Access Compliance Report

Public Rights-of-Way

(Curb Ramps)

Intersection ID: 10022902	Main Street: CAYMAN_WY	Cross Street: N/A	Location:	N
ADA ID: 1B80C3996FD6	Ramp Type: Perp	Initial Pass/Fail: Fail	Overall Compliance: No	Severity Score: 22.5
Codes/Mitigation Info/Possible Solution		Field Measurements/Component Compliance

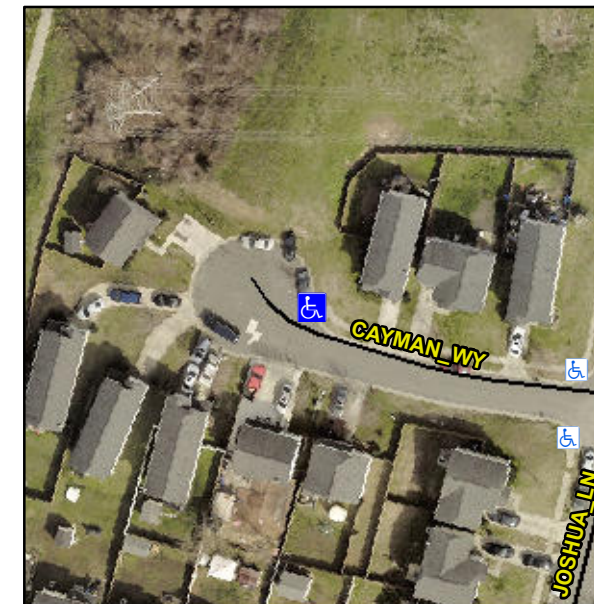
Not Found, R304.5.1, R304.2.2, R304.5.3

Compliance	Description	Data	Compliance	Description	Data
N/A	Ramp Length (in)	48.0	No	Ramp Slope (%)	8.5
No	Ramp Width (in)	47.0	No	Ramp XSlope (%)	4.4
N/A	Flare Type LT	N/A	N/A	Flare Type RT	N/A
N/A	Flare Slope LT (%)	N/A	N/A	Flare Slope RT (%)	N/A
N/A	Flare Traversable LT?	N/A	N/A	Flare Traversable RT?	N/A
N/A	Landing Length (in)	N/A	N/A	DWS Provided?	N/A
N/A	Landing Width (in)	N/A	N/A	DWS Contrast?	N/A
N/A	Landing Slope (%)	N/A	N/A	DWS Length (in)	N/A
N/A	Landing X Slope (%)	N/A	N/A	DWS Full Width?	N/A
N/A	Landing Curb? (Y/N)	N/A	N/A	DWS Offset (in)	N/A
N/A	Shared Landing?	N/A			
N/A	Gutter Ponding?	N/A	N/A	Gutter Slope (%)	N/A
N/A	Gutter Lip Ht (in)	N/A	N/A	Gutter X Slope (%)	N/A
N/A	Painted X Walk1?	No	N/A	Painted X Walk2?	N/A
	X Walk 1 Direction	To W		X Walk 2 Direction	N/A
N/A	X Walk 1 Width (in)	N/A	N/A	X Walk 2 Width (in)	N/A
	X Walk 1 Slope (%)	7.0		X Walk 2 Slope (%)	N/A
	X Walk 1 X Slope (%)	1.9		X Walk 2 X Slope (%)	N/A

Remove & Replace Entire Ramp.
